Dam Siting

Larimer County NISP 1041 Hearing

August 24, 2020

Dr. Sally Sutton

WHY BUILD A DAM ON FAULTED, WATER-SOLUBLE, PERMEABLE ROCK??

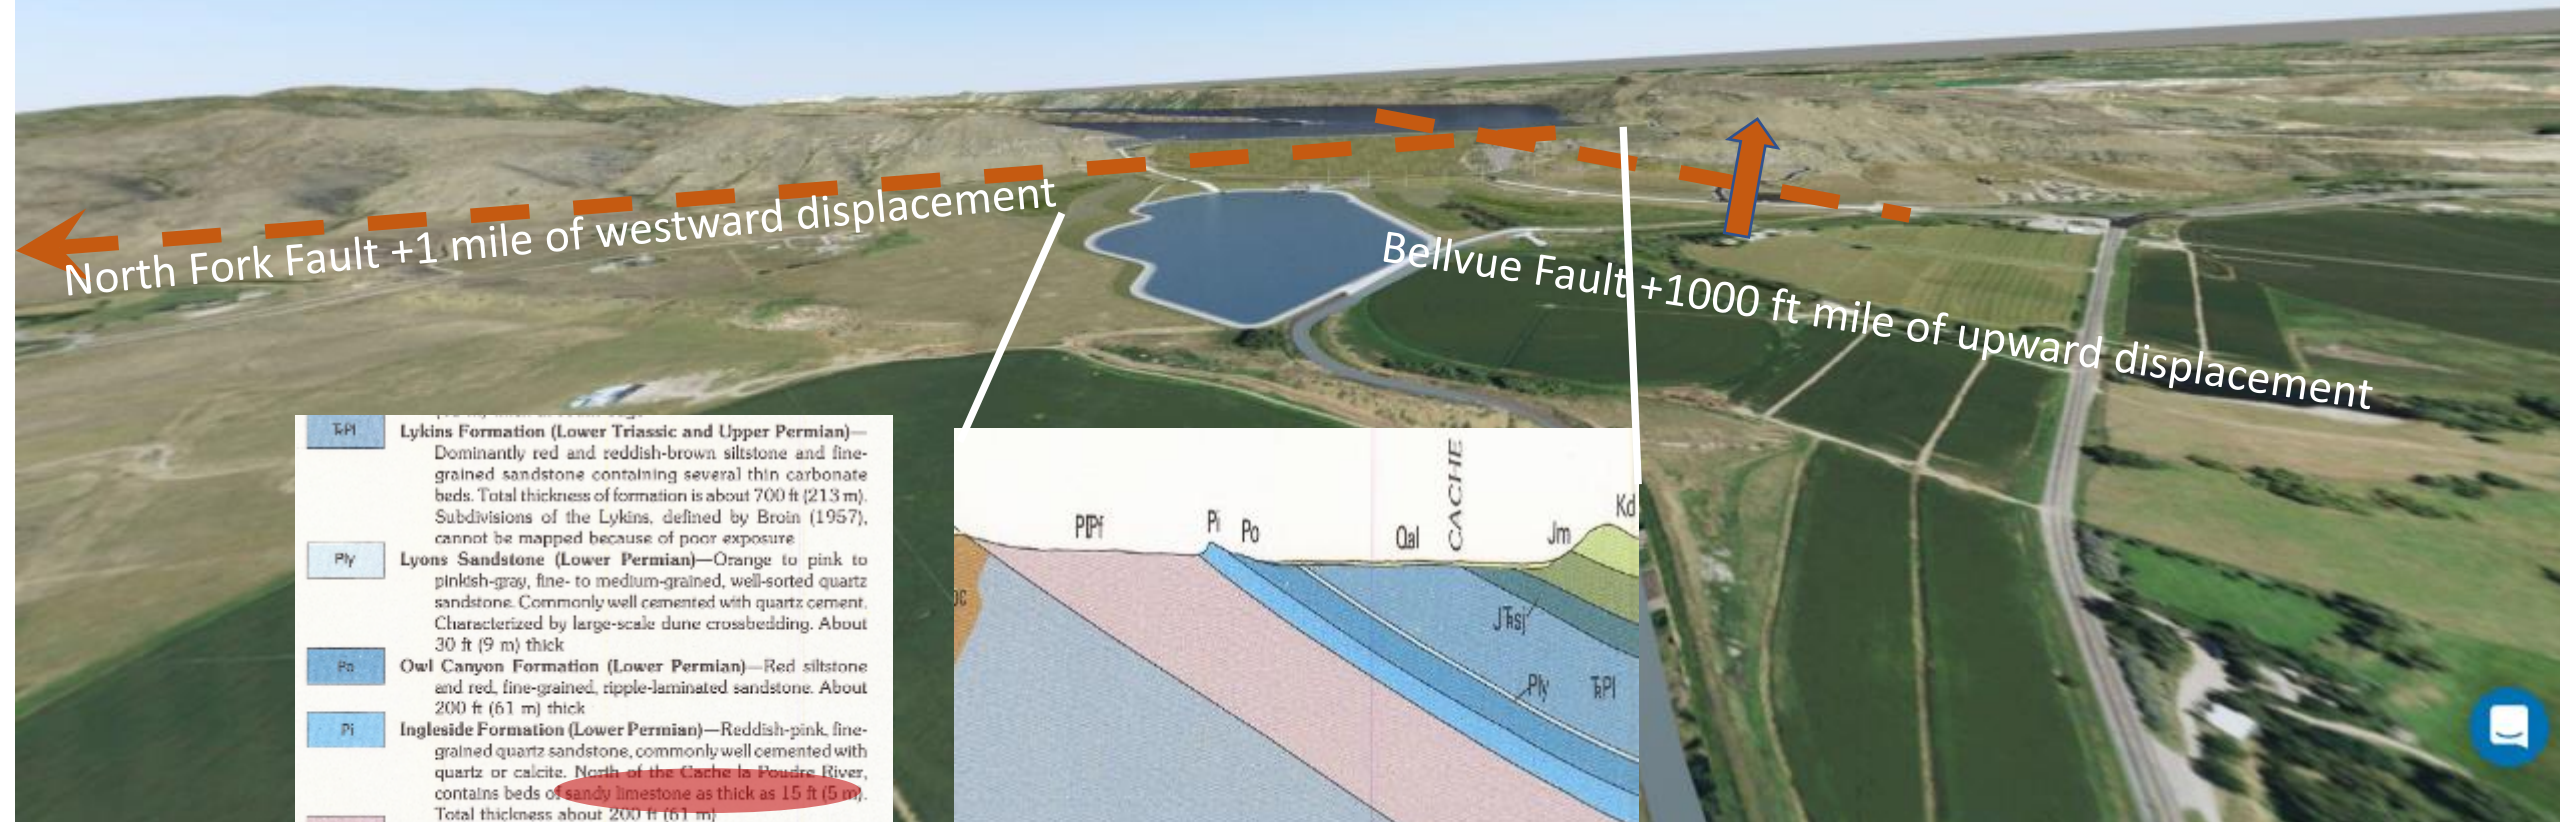
Geologically, Glade is a worse setting than the North Dam... yet solutions (\$\$\$\$) Northern needed at the North Dam are absent at Glade

The sedimentary layers underlying the site include permeable conglomerates (ancient gravel deposits) as well as soluble carbonate and gypsum-rich layers. Large seepage losses are likely and there is a risk of dam failure....

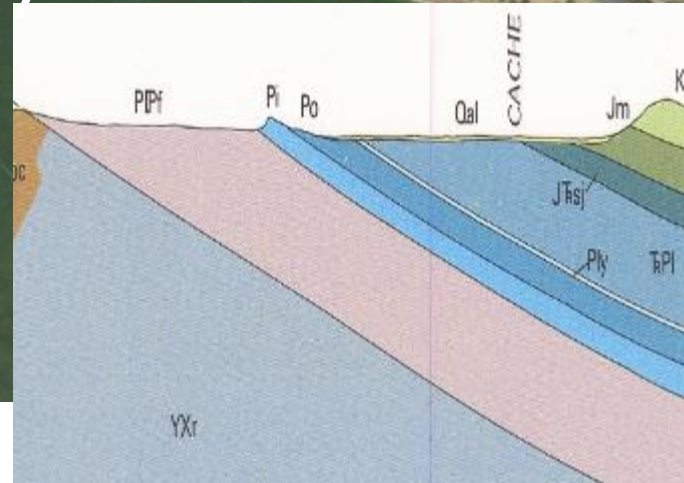
Anecdotal reports from drillers indicate high capacity water wells, supporting concerns about permeability in the underlying rocks. Outcrops display dissolution voids that will be difficult to find and/or address.
